Before the
FEDERAL COMMUNICATIONS COMMISSION
Washington, D.C. 20554

In the Matter of)	
)	
Amendment of Parts 73 and 90)	RM-9719
of the Commission's Rules)	
to Authorize the Transmission)	
of Emergency Signals on Channel 200)	
)

Comments of the Society of Broadcast Engineers, Inc.

SBE Comments: RM-9719 (ERDS on 87.9 MHz)

Section 73.599, Figure 1, with Extrapolated Channel 200 Curve

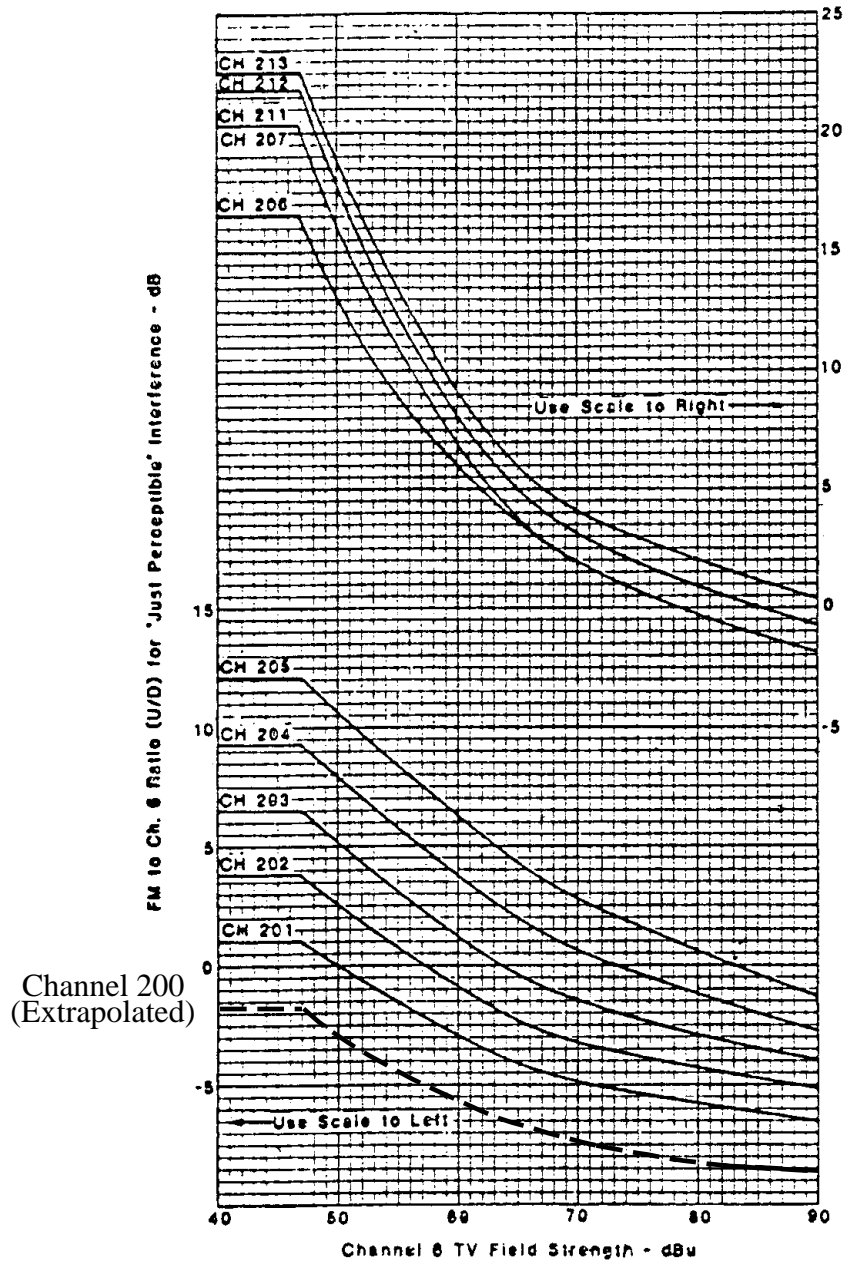
13. One can then conclude that at the Grade B (47 dBu) contour of a Channel 6 TV station, a D/U ratio of +3.5 dB is required to avoid interference, with this ratio relaxing to approximately -8 dB for a very strong Channel 6 field strength of 90 dBu (*i.e.*, 16 dB above the 74 dBu City Grade contour for Channel 6 stations). SBE notes that the Federal Signal petition's claimed D/U ratio for no interference to Channel 6 television receivers is therefore 13.5 dB more lenient than the Section 73.599 FCC Figure 1 could be deduced to show. SBE therefore does not find the Federal Signal petition credible in its claim of no interference to Channel 6 reception, and concludes that shortcoming, by itself, should be treated as a fatal flaw to the Petition.

14. Yet another flaw in the Exhibit E treatment of Channel 6 interference is the assumption that the Channel 6 TV station is transmitting with an aural-visual power ratio of -7 dB (*i.e.*, 20% aural power). In reality, most TV stations transmit with aural-visual power ratios of only -10 dB (*i.e.*, 10% aural power), and many TV transmitters are not even capable of operating at more than 10% aural power. Therefore, Federal Signal's presumption of Channel 6 aural ERPs 3 dB higher than commonly used is again a fatal flaw to its Petition.
